ADDENDUM

Renovations to:
Landfall Dye Clubhouse

ADDENDUM #2

Renovations to
The Country Club of Landfall
Dye Club House
Wilmington, NC 28405

1b - Ground Level Bar Shelving

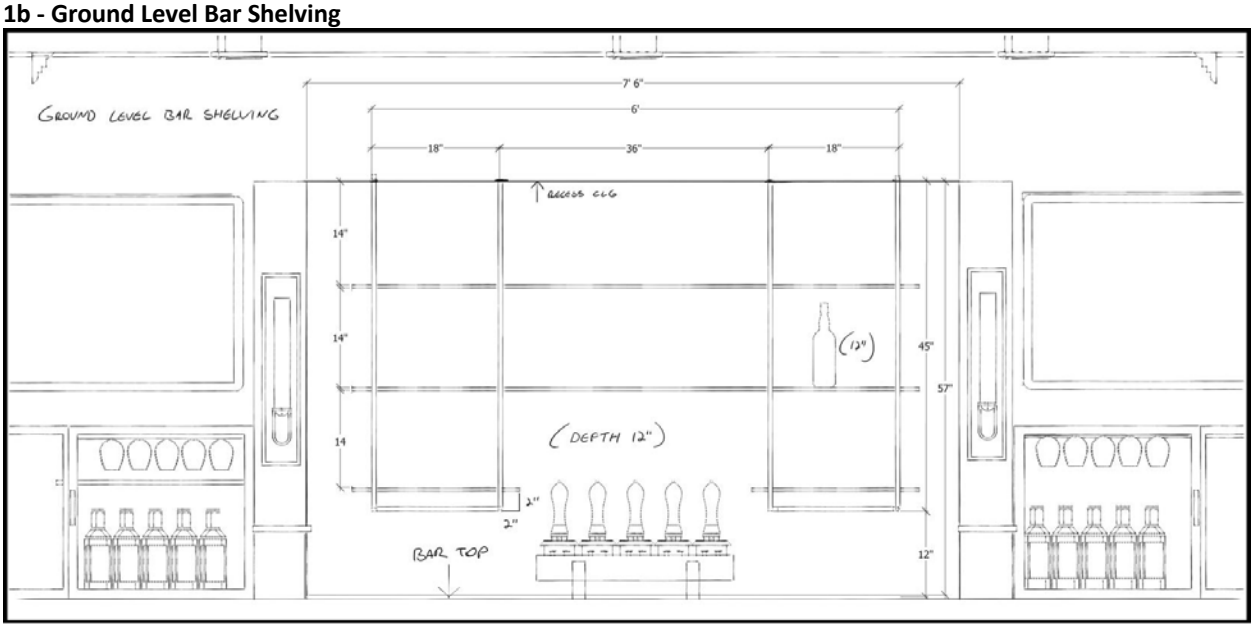
Request from Stephenson's Millwork - Please provide specifications for the brass shelving and sliding door hardware at the bar area.

- Brass Shelving System: Ground Level Bar: Brass ceiling-hung bars with wood shelves (rendering attached: 1a. Specifications attached: 1b.). Shelving depth is 12" (recess overall is 15"d). Shelf thickness, ¾".
- Brass Shelving System: Upper Level Bar: Brass ceiling-to counter bars with 3form shelves (rendering attached: 1c.)
- Sliding Door Hardware: Ground Level Bar: Emtek Modern 4" Rectangular Recessed Pull in French Antique Brass, EMT-311453

3c - Specifications for tile pattern utilizing tiles 4, 5, 6, 7 at Women's 103

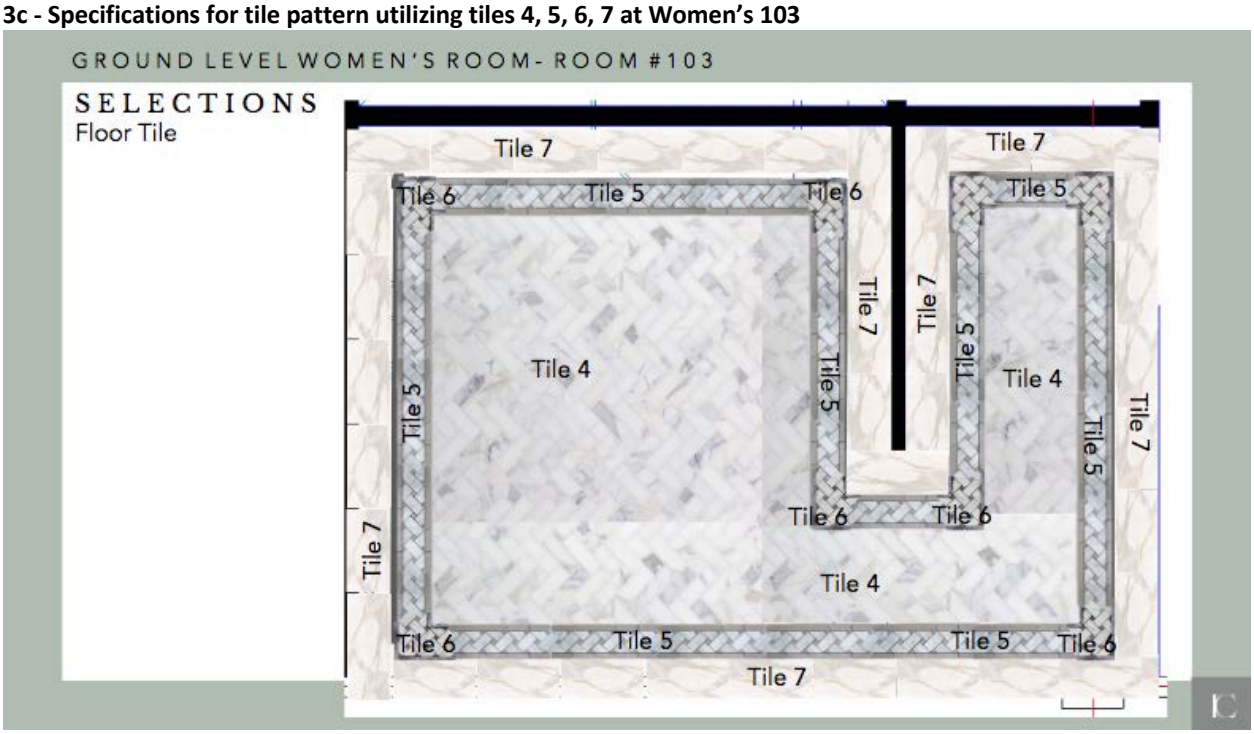
Request from Flooring Solutions - Please provide detail for:

a. Floor tile pattern utilizing tiles 4, 5, 6, & 7 at Women 103
b. What is the height of Tile 13 wainscotting at Men 210
c. Detail of carpet border at room 202 & 203

- a: Rendering attached (3a). Specifications attached (3b & 3c).
- b: 42"h wainscot tile. Sink wall: tile will go to the ceiling.
- c: Will use a 15" wide solid color carpet border around the perimeter of the entire space. The solid carpet for the border comes 12' wide. Will be bordered only around the full Veranda and Ballroom (treating them as one room). Border will not split Veranda / Ballroom.

1 / A2.0 FIRST FLOOR RENO PLAN

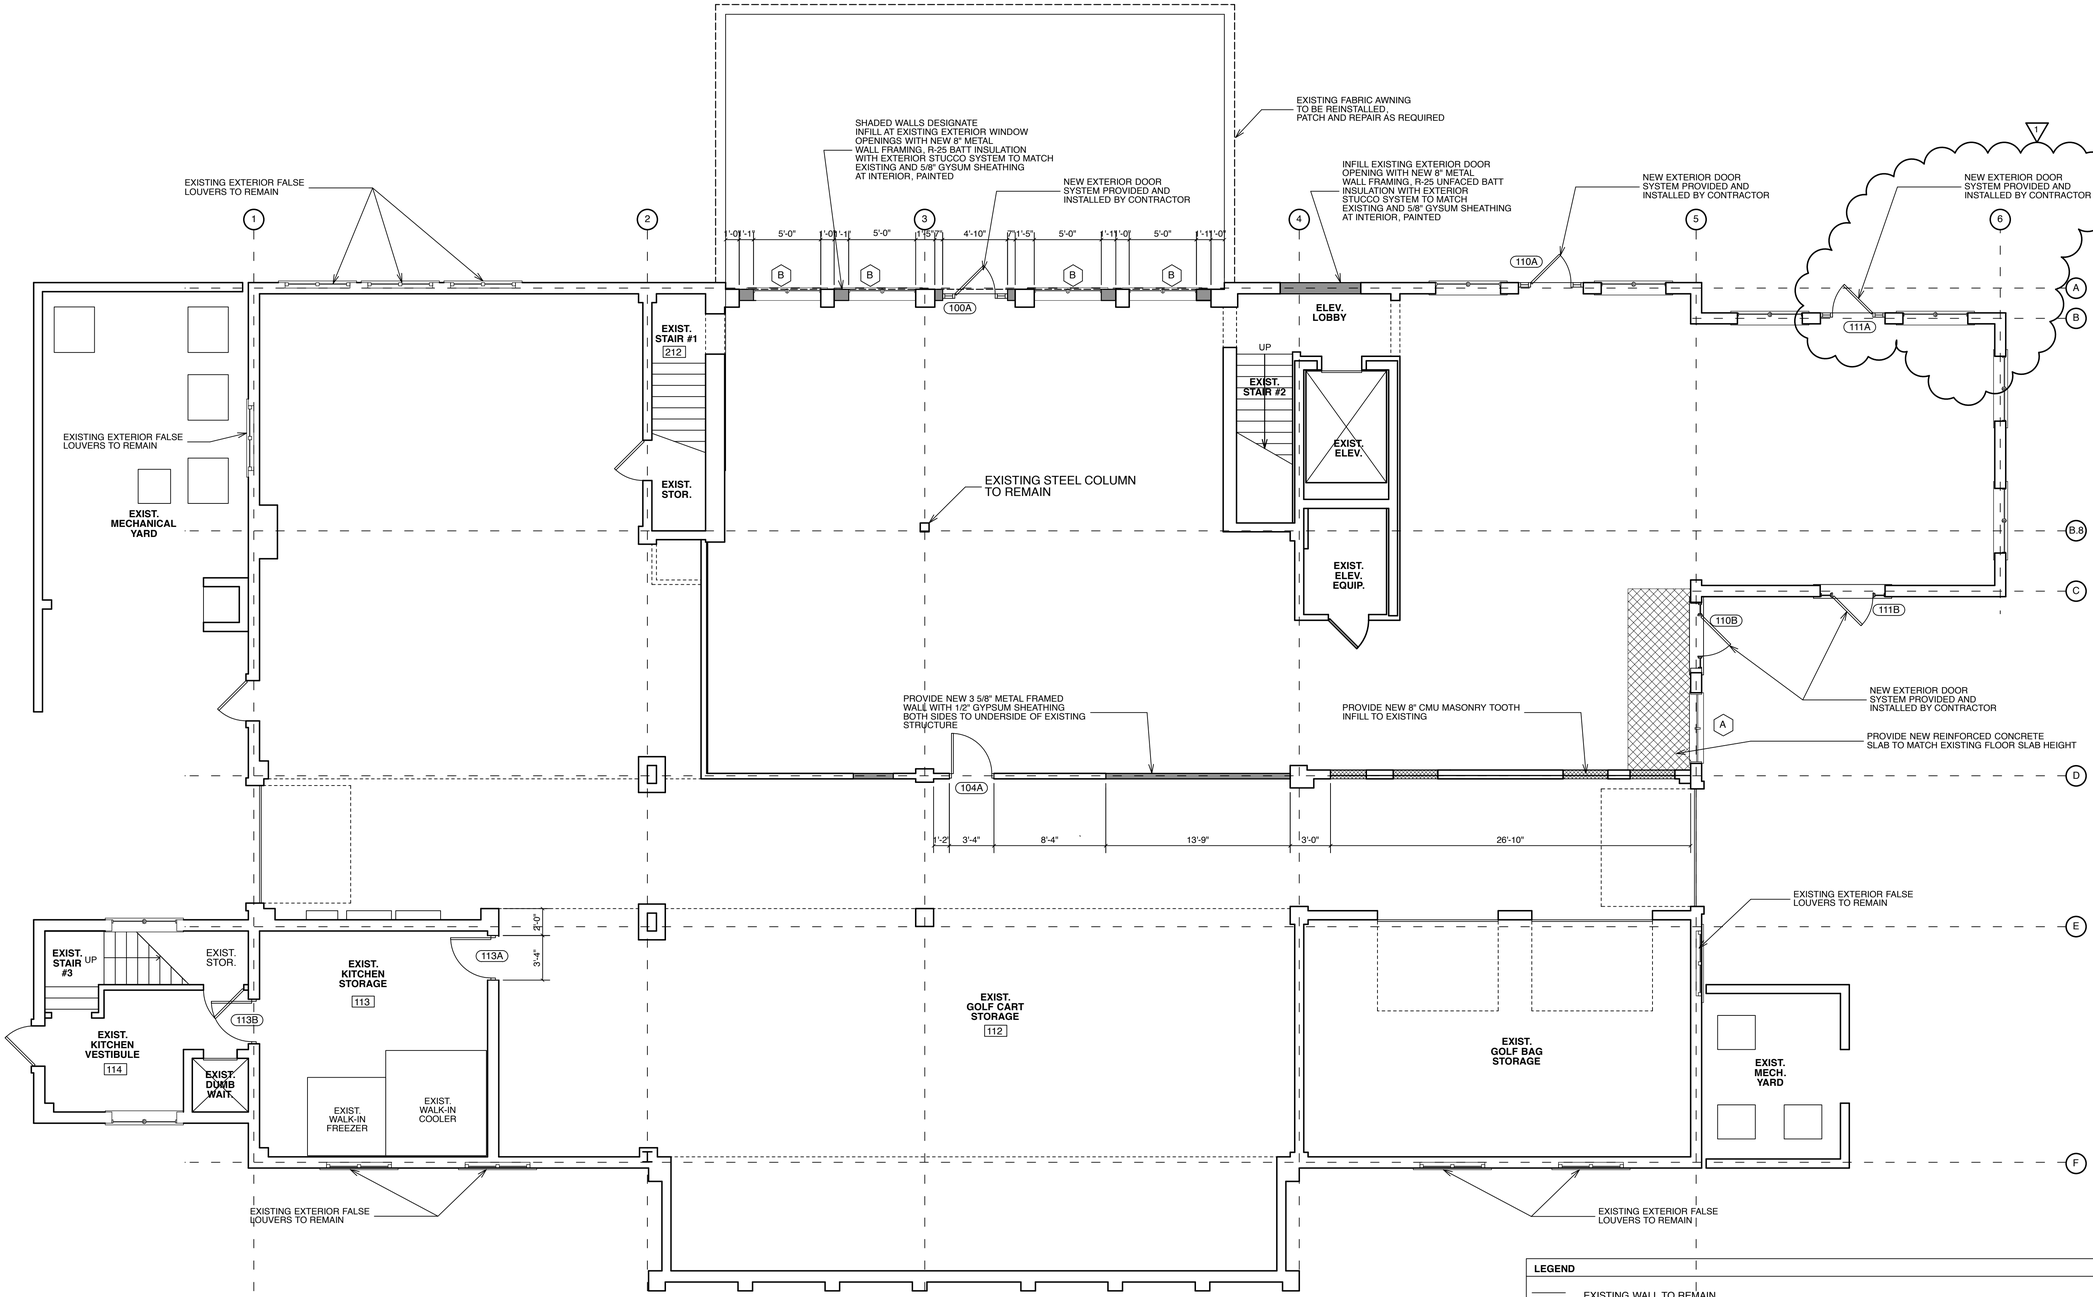
Item 2 ASI #1 has been previously issued and contains the following revisions. A new door was added to the proshop. Please reference revised sheets A2.0 and A3.0 included in attached ASI #1. Reference ASI #1 included as **attachment #2**.

1 / A7.1 **SECOND FLOOR REFLECTIVE CEILING PLAN**
Scale: 3/16" = 1'-0"

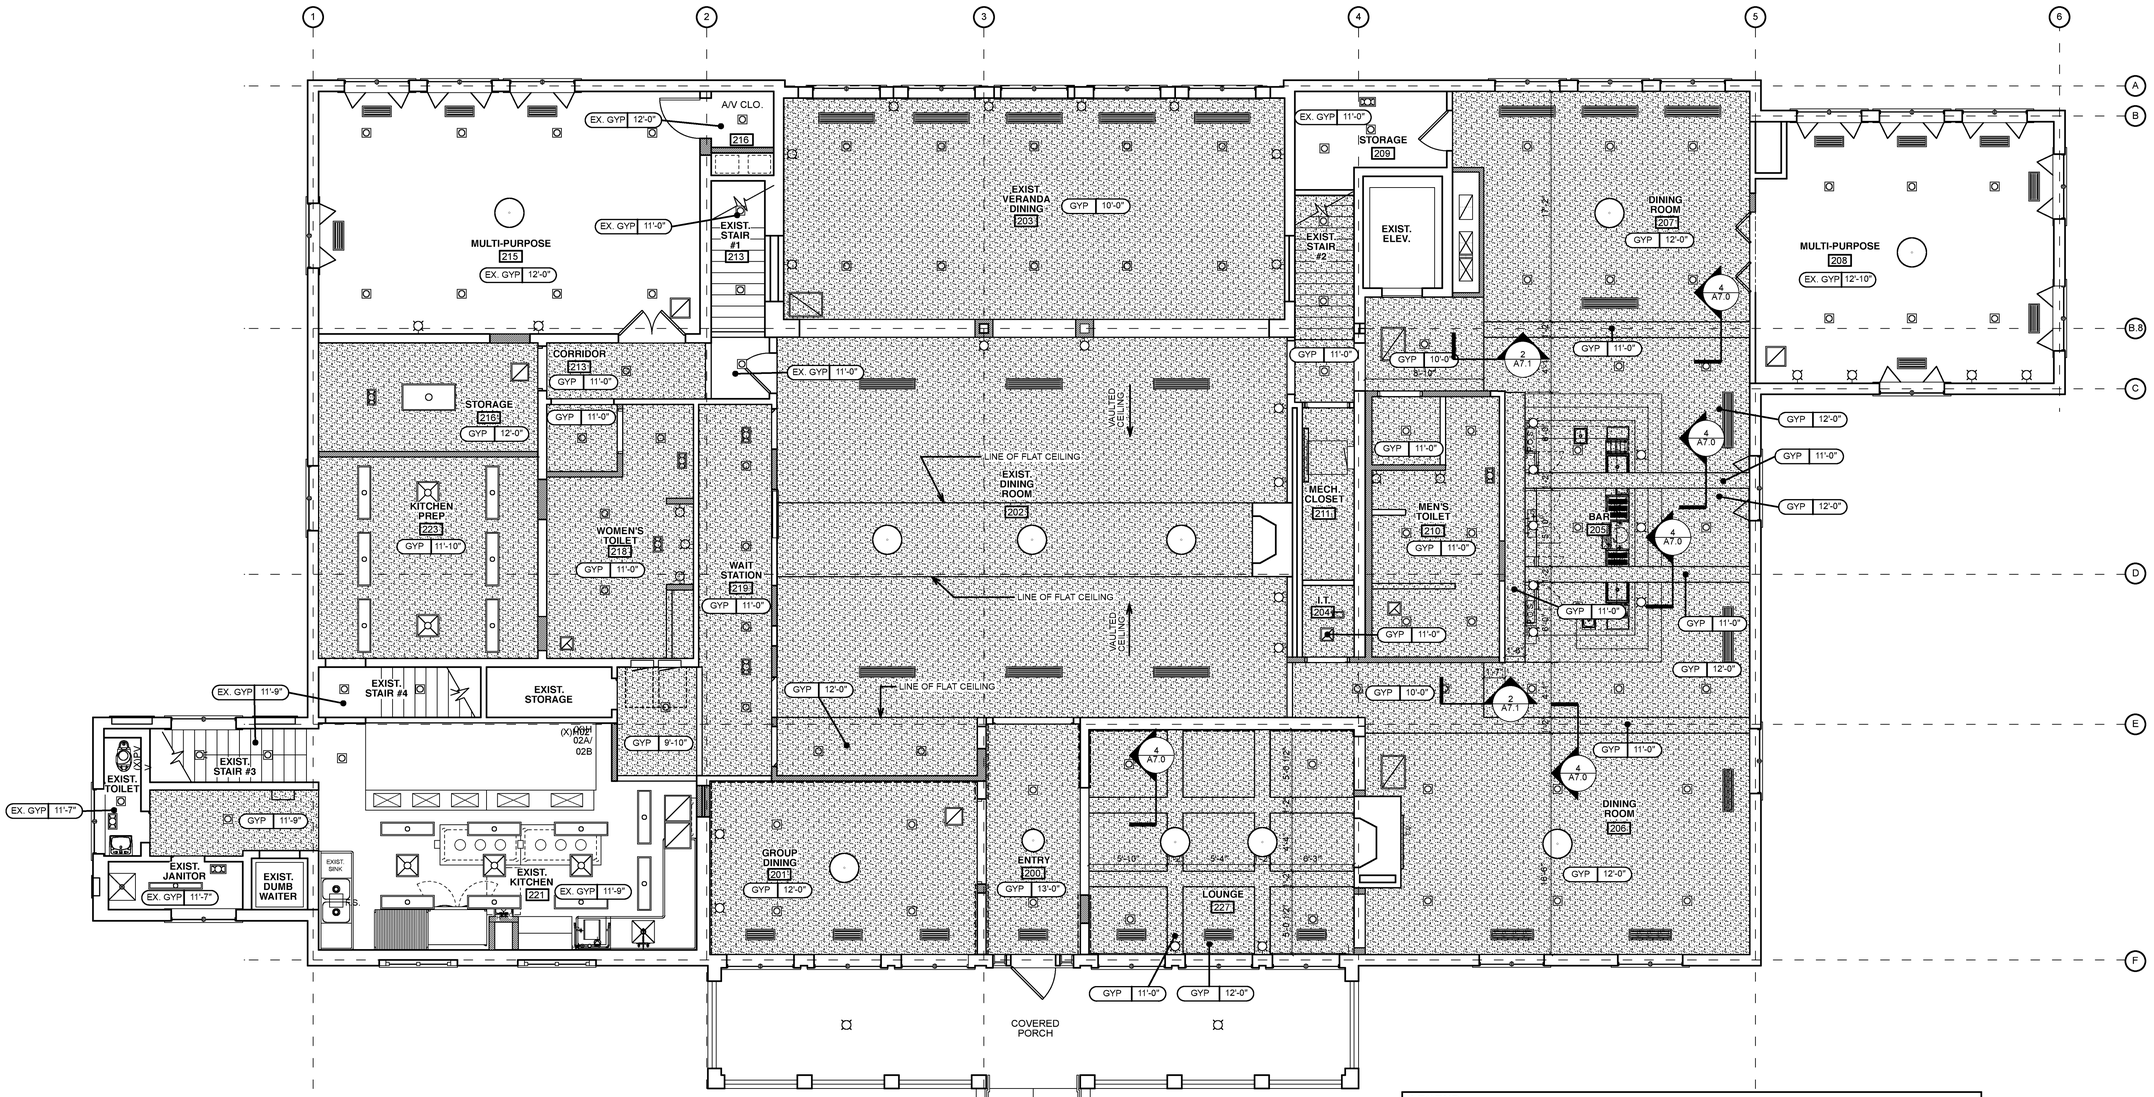
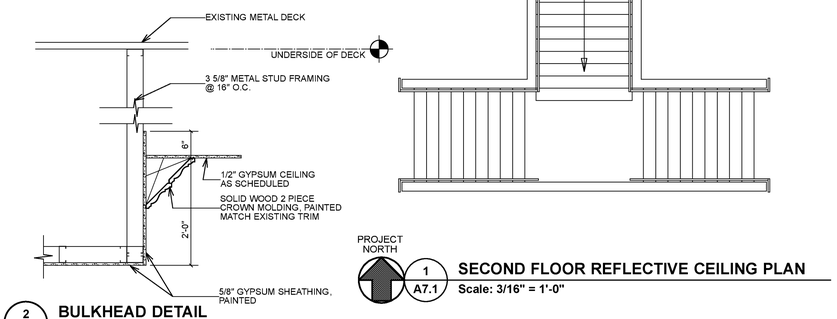
Item 10 Drawings: A7.1 Clarification. Demolish existing ceiling and provide new gypsum ceilings in Dining Room 207 and Lounge 227. Demolish existing ceiling and provide new gypsum ceiling in

Mutipurpose Room 208. Remove existing ceilings in all areas with ceiling remaining and replace as necessary when required for HVAC, lighting or sprinkler work.

1 / EL1.2 **SECOND FLOOR PLAN**
scale: 3/16"=1'-0"

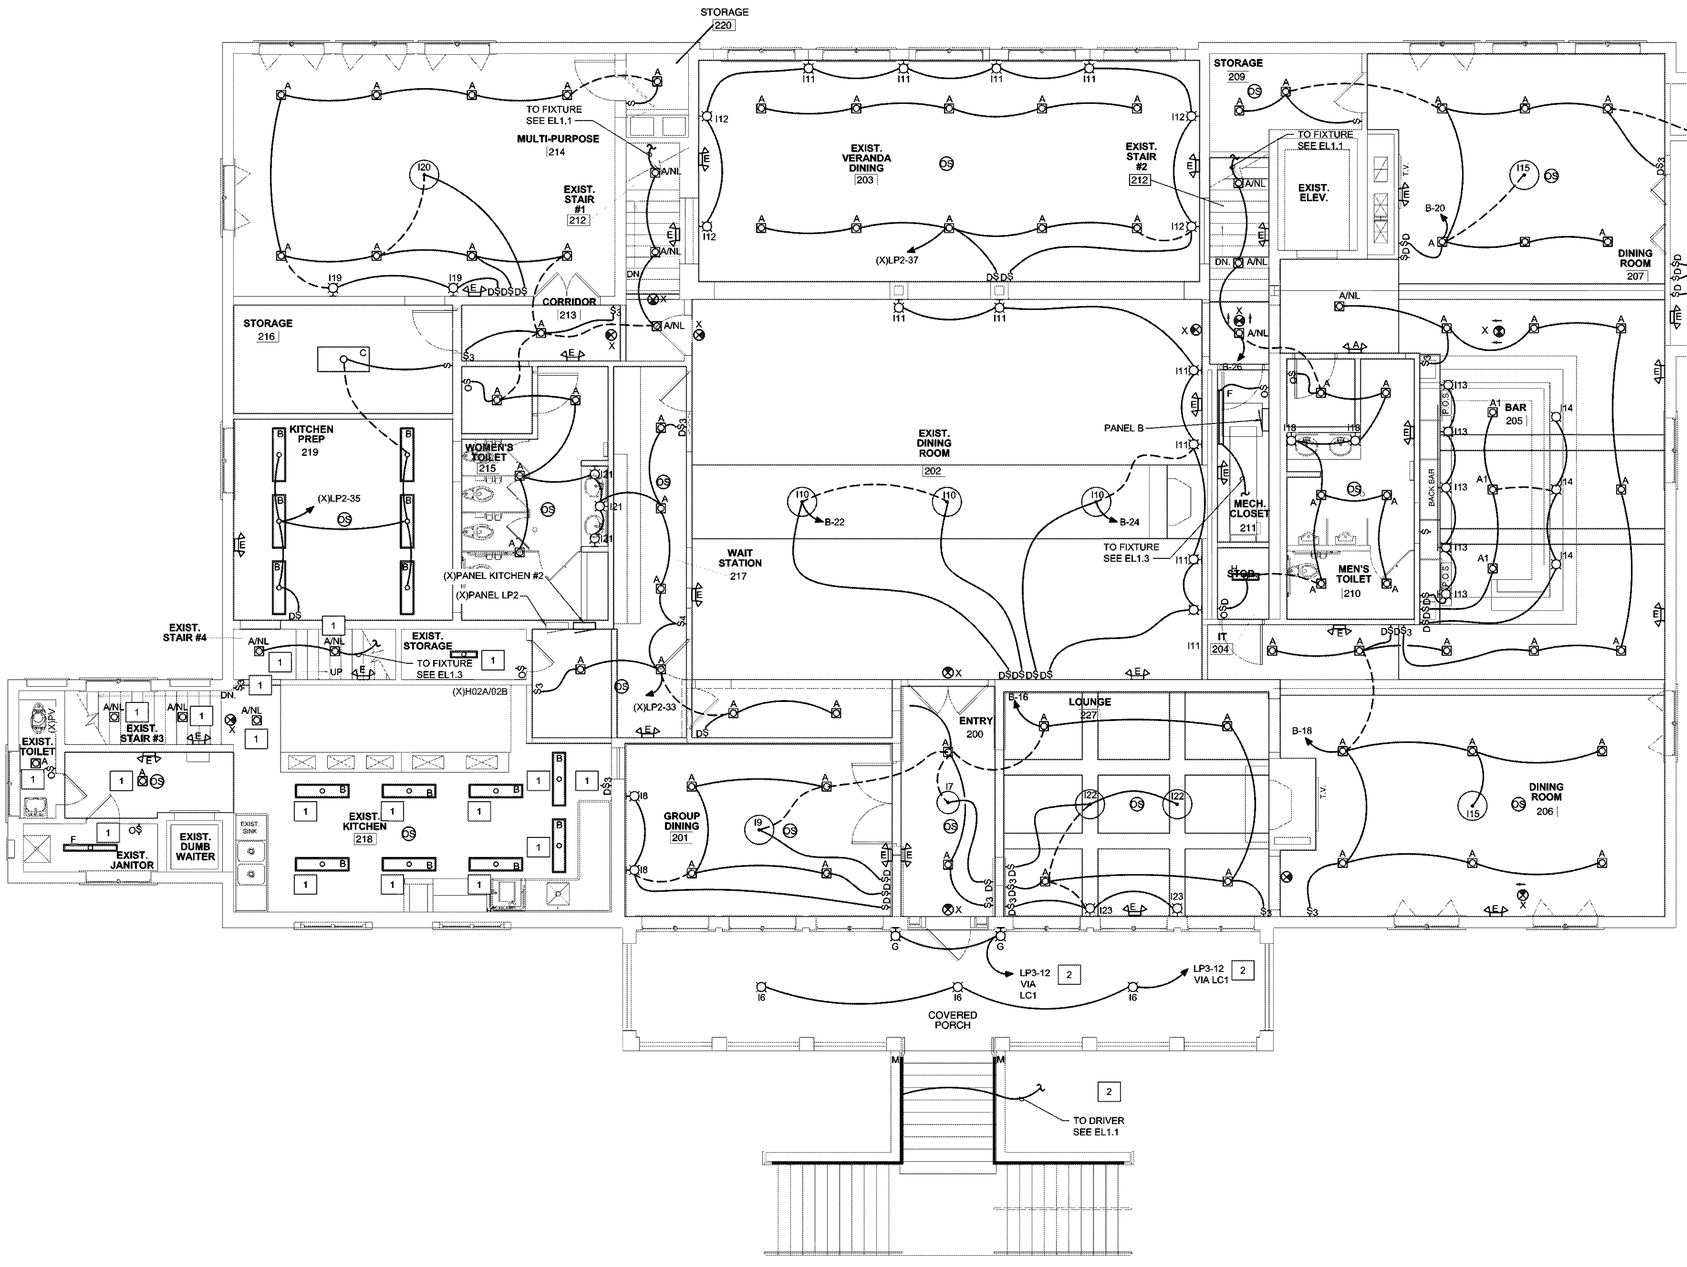
Various The architectural, electrical and mechanical sheets have been revised to reflect aesthetic alignment of diffusers and lights. A flat section of ceiling has been added to the second floor dining room. The fixture count went down by 2, one on each floor. A dimmer was added to the area that opens into Main Dining Room for 2 can lights. Reference reissued sheets A7.0, A7.1, EL1.1, EL1.2, M1.1, M1.2. Reference Addendum #1 included as **attachment #1**.
